SAFETY EVALUATIONFORVALIDATION OF BECHTEL COMPUTER CODE SASSI FOR APPLICATION TO  
WATTS BAR NUCLEAR PLANT SOIL-STRUCTURE INTERACTION ANALYSISTENNESSEE VALLEY AUTHORITY (TVA)WATTS BAR NUCLEAR PLANT (WBN) UNITS 1 AND 2DOCKET NOS. 50-390 AND 50-391

## 2.0 PURPOSE AND SCOPE

Fig. 11 5% Damping Response Spectra of Recorded Ground Motions  
at Different Depths at Station DHB, Event LSST07 (Ref. 7)

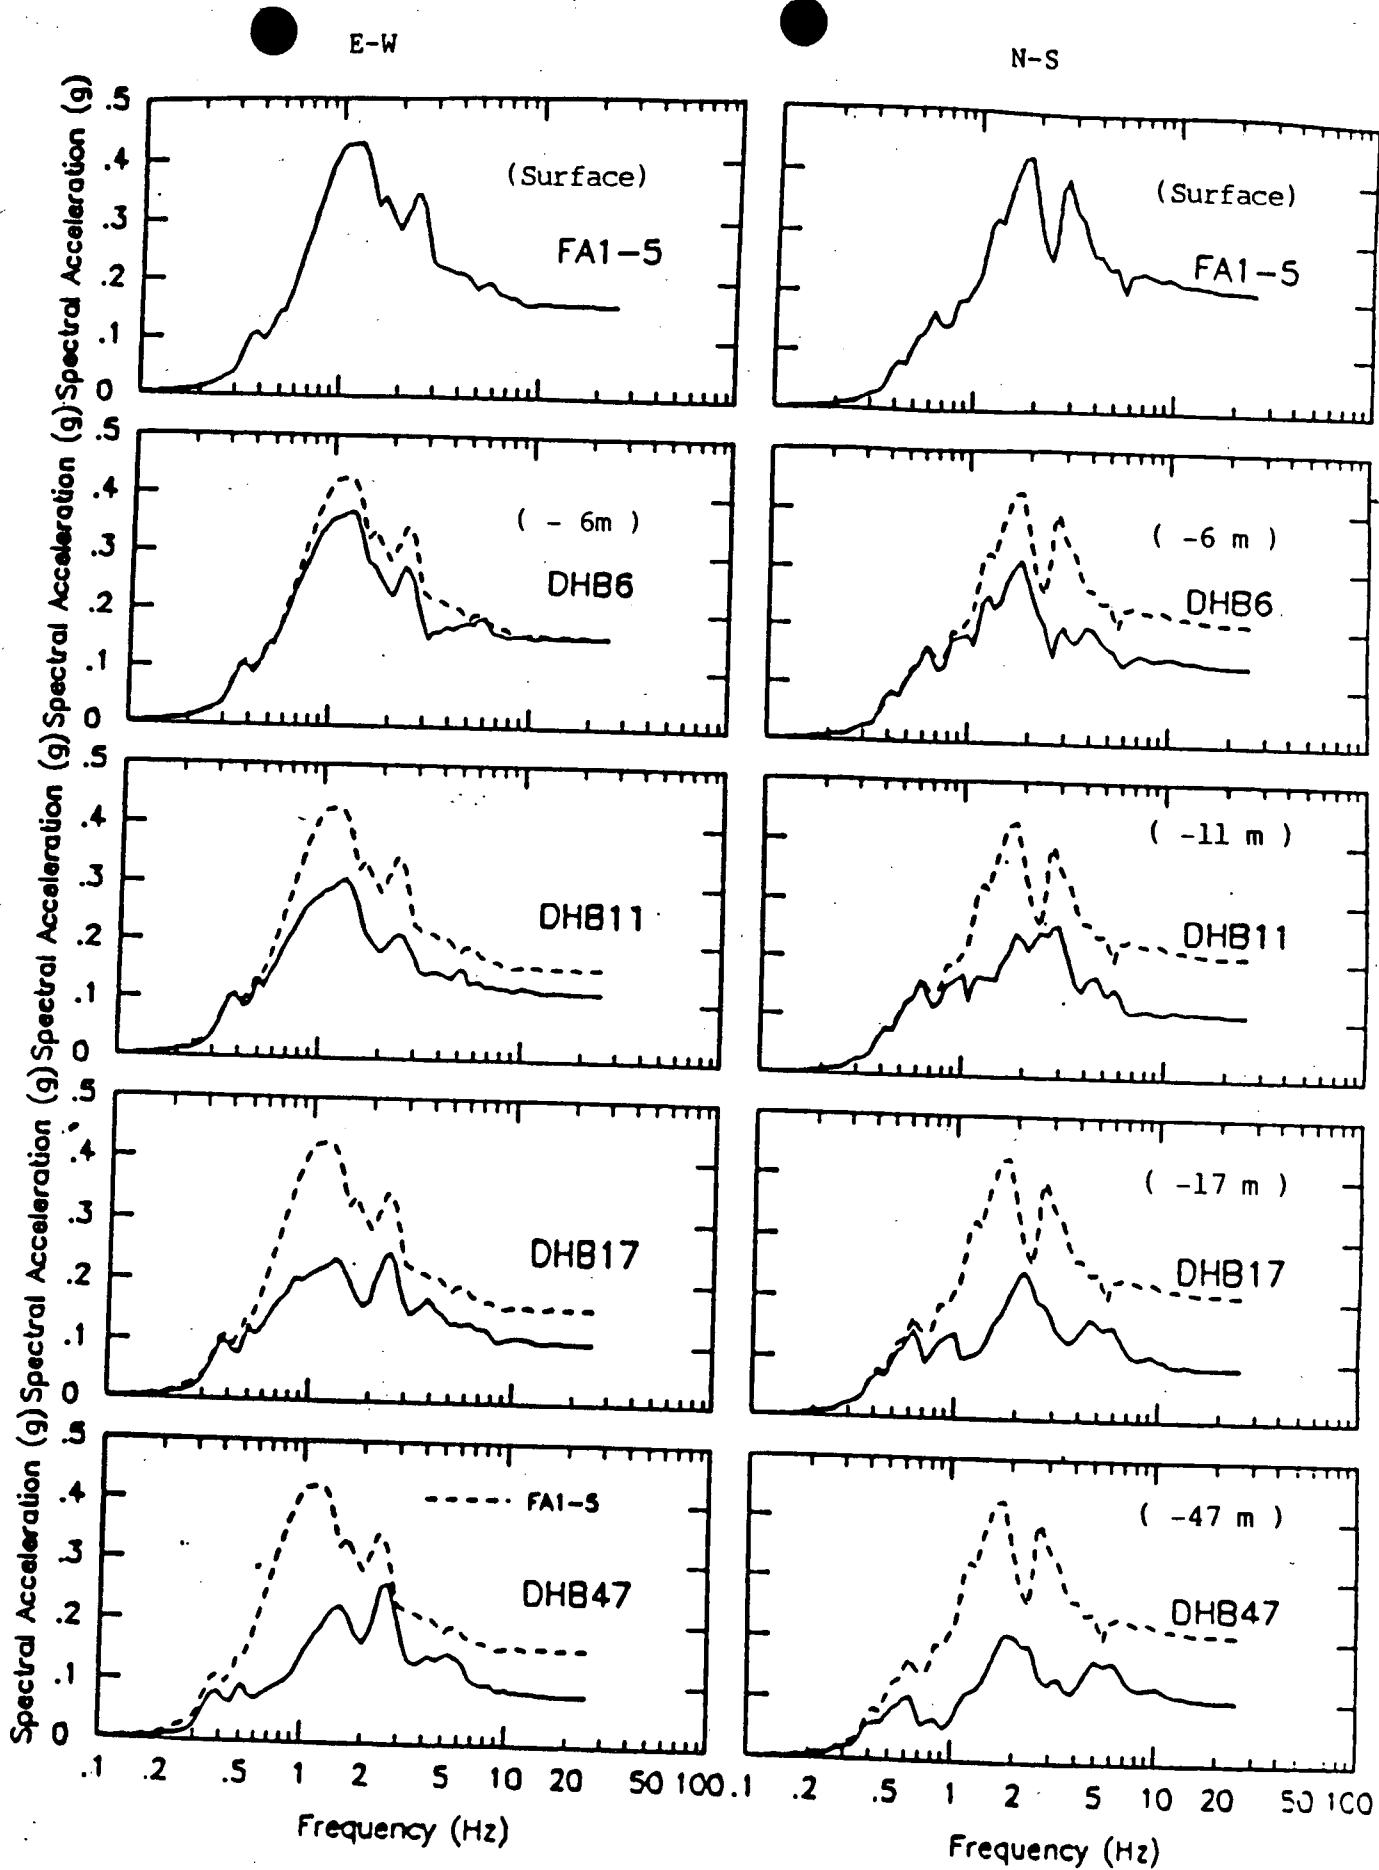
- (5) As discussed previously in finding (3), the staff and consultant noted the significance of wave scattering on the response of the DGB and RWST due to the structural embedment. The spectrum comparison for motions A, B and D as shown in Fig. 9 led to the same observation. As an additional evidence, Bechtel provided a summary of the results from some published studies on several strong-motion earthquakes (Ref. 7). The scaled model is located in Lotung, Taiwan, and is moderately embedded in a soft soil foundation. Fig. 10 illustrates the vertical cross section of the scaled containment model. Fig. 11 shows the variation of the recorded free-field motions from the surface to -47m in the ground during one of the earthquakes. The earthquake,

denoted by Event LSST07, took place on May 20, 1986. Relative to the surface motion, a reduction in response spectrum is noticeable at -6m, which is about the same elevation as that of the bottom of the basemat. Reduction in the NS direction is more pronounced. Fig. 12 provides a spectrum comparison for the recorded and computed motions at the top of the basemat for Event LSST07. The computed motion was obtained using the CLASSIF code both with and without considering the effect of foundation scattering (or kinematic interaction). For the case including the effect of wave scattering, the scattering functions were generated from a SASSI analysis. Fig. 12 suggests that wave scattering due to the structural embedment is important to the interpretation and correlation of the SSI response recorded in the containment model. The effect of wave scattering is more pronounced in the NS direction, which is consistent with the larger reduction in free-field motion taking place at -6m in the NS direction.
